Determination 2016/057

Regarding the performance of a concrete floor slab and foundation with respect to moisture transmission to a house at 5 Main Road, Redcliffs, Christchurch

Figure 1: Site plan

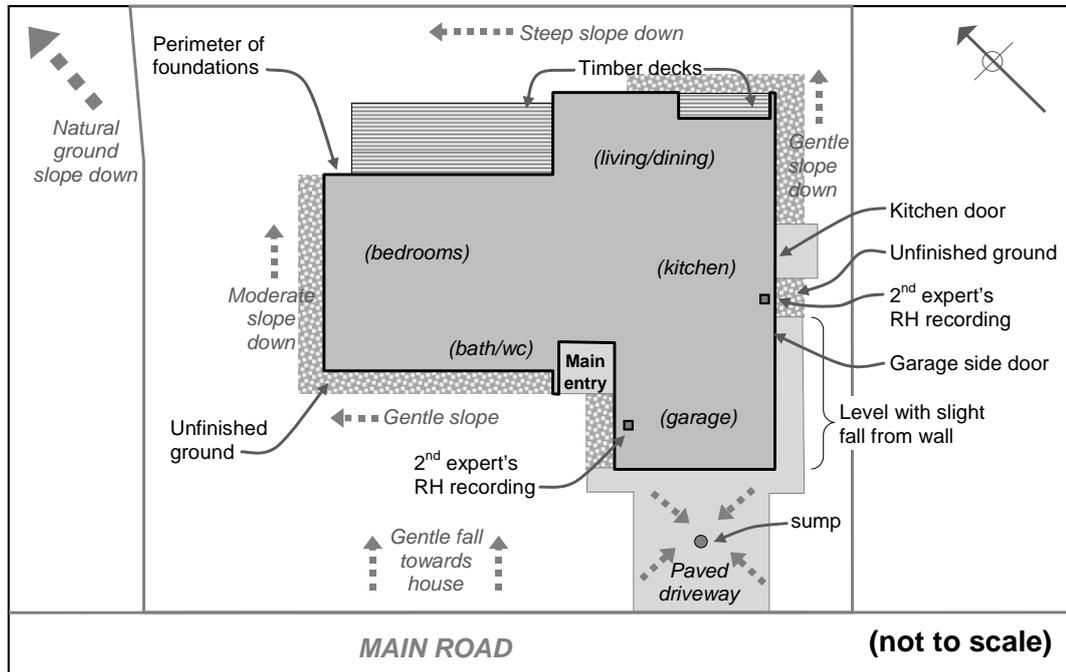
- 5.2.1 The expert checked the site levels against a datum at the west corner of the garage (see Figure 1) and noted that:
- ground between the southwest elevation and the street lacks topsoil and currently slopes gently down toward the house
 - ground levels against northwest wall fall more steeply towards north corner
 - most ground to the southeast elevation is paved, with limited clearances to the finished floor level ("FFL") and a slight slope away from the wall
 - ground levels to northeast elevation fall fairly steeply from about 1m below the FFL at the east corner towards the north corner
 - the driveway slopes gently towards a sump in the middle of the drive.
- 5.2.2 The expert also noted that downpipe locations accord with the consent site plan and testing surface water drainage with a hose confirmed satisfactory operation.

- 6.2.3 The expert also used two data loggers¹⁴ to record movements in relative humidity (“RH”) within the garage slab near the southwest wall and at the east corner (see Figure 1). The expert noted that after 16 hours RH measurements ranged from:

Figure 2: Foundation detail in architectural drawings with my notes added

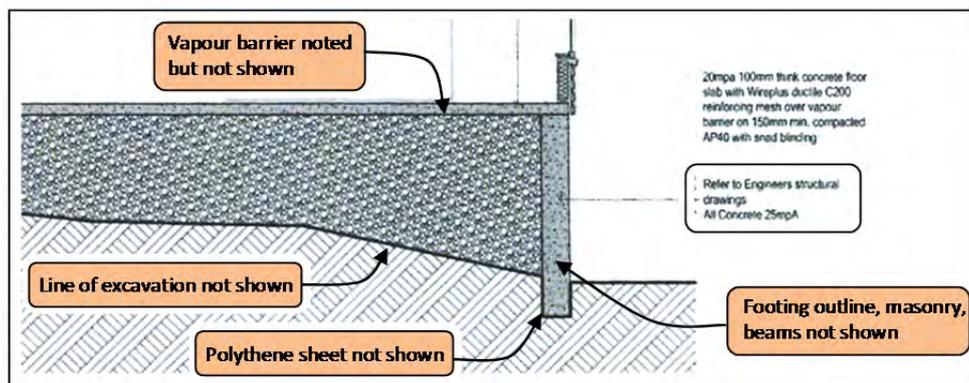
- Any 'swimming pool effect' created by the polythene-lined excavation contour (see Figure 2) is limited to the northeast perimeter walls due to the site slopes. No investigations identified evidence that ponding actually occurs and there are no signs of efflorescence or moss growth at the base of the visible blockwork.

8.4.1 I consider that the various reports establish that the concrete slab was not installed in accordance with the consented architectural drawings and must therefore be assessed as an alternative solution. However, as shown in Figure 2 and Figure 3 the consent documentation is not consistent in regard to particular requirements for the slab and foundation.

Figure 3: Foundation detail in engineering drawings with my notes added

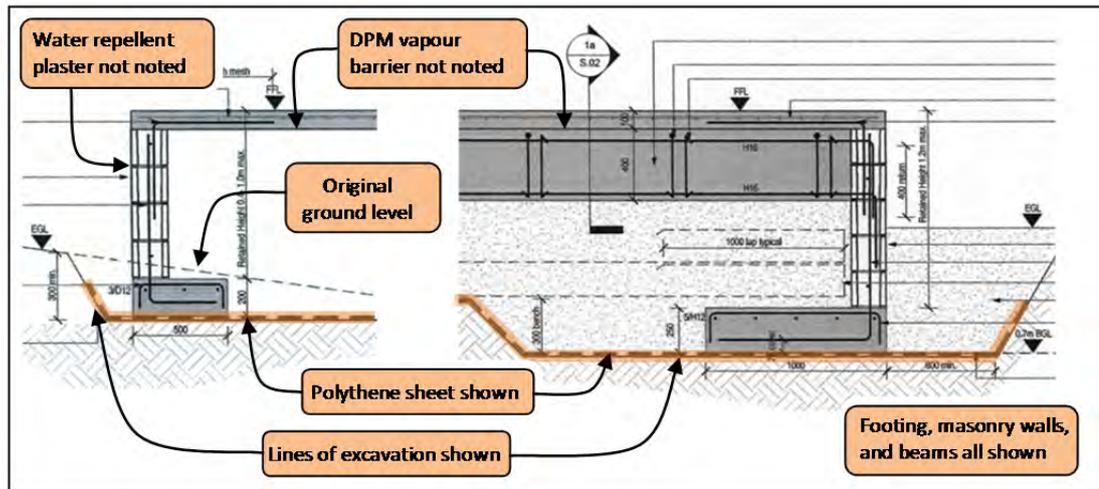
- It has not been demonstrated that the slip layer of polythene was installed to the standard required ‘for a product intended to perform as a DPM for the purpose of E2’ and photographs indicate it was not installed in accordance with the drawing at Figure 3 (refer paragraph 3.1.3).
